Access Compliance Report Public Rights-of-Way (Curb Ramps)

Main Street: CROWN_VALLEY_PKWY Cross Street: CROWN_VALLEY_PKWY Location: SW

ADA ID: RPRK211101121720 Ramp Type: Type 1 - Perpendicular Diagonal Initial Pass/Fail: Pass Overall Compliance: No Severity Score: 16

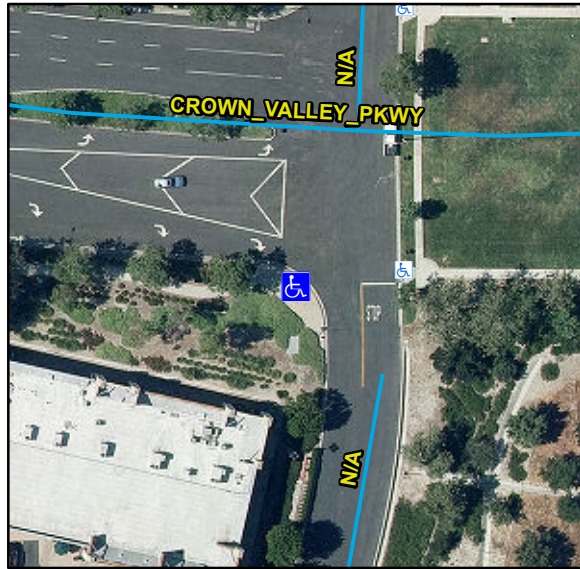
Compliance	Description	Data	Compliance	Description	Data
N/A	Ramp Length (in)	118	N/A	Flare Type LT	
Yes	Ramp Width (in)	48			Sloped
Yes	Ramp Run Slope (%)	5.5	Yes	Flare Slope LT (%)	4.2
Yes	Ramp Cross Slope (%)	0.3	N/A	Flare Traversable LT	Yes
N/A	Landing Present	Yes	N/A	Flare Type RT	
N/A	Landing Length (in)	51			Sloped
Yes	Landing Width (in)	48	Yes	Flare Slope RT (%)	1.7
No	Landing Run Slope (%)	3.6	N/A	Flare Traversable RT	Yes
Yes	Landing Cross Slope (%)	0.2	No	DWS Provided	No
N/A	Landing Movement Obstructed?	Yes	N/A	DWS Contrast	N/A
	Landing Movement Type	Bushes	N/A	DWS Length (in)	N/A
N/A	Landing Shared	No	N/A	DWS Full Width	N/A
N/A	Clear Space	Yes	N/A	DWS Offset Left (in)	N/A
N/A	Clear Space To Crosswalk (in)	48	N/A	DWS Offset Right (in)	N/A
N/A	Marked Crosswalk 1	No	N/A	Marked Crosswalk 2	No
	Crossing 1 Direction	E		Crossing 2 Direction	N
	Marked Crosswalk 1 Width (in)	N/A		Marked Crosswalk 2 Width (in)	N/A

N/A	Ramp Inside Crosswalk 1	N/A	Yes	Ramp Inside Crosswalk 2	N/A
	Crossing 1 Slope (%)	1.2		Crossing 2 Slope (%)	2
	Crossing 1 Cross Slope (%)	1.2		Crossing 2 Cross Slope (%)	2.6
Yes	Gutter Ponding	No	No	Curb Slope	5.2
Yes	Gutter Lip Height (in)	0		Road Run Slope (%)	0.1
No	Gutter Run Slope (%)	5.3		Road Cross Slope (%)	0.9
Yes	Gutter Cross Slope (%)	0.6			
Yes	Overall Surface Condition: Acceptable		Yes	Perp Joint Present	Yes
	Cross Gutter Present?	No		Spandrel Present?	No
	Replace Cross Gutter?	N/A		Replace Spandrel?	N/A

Remove & Replace Curb Ramp With Two New Directional Ramps or Equivalent. Remove & Replace Gutter.
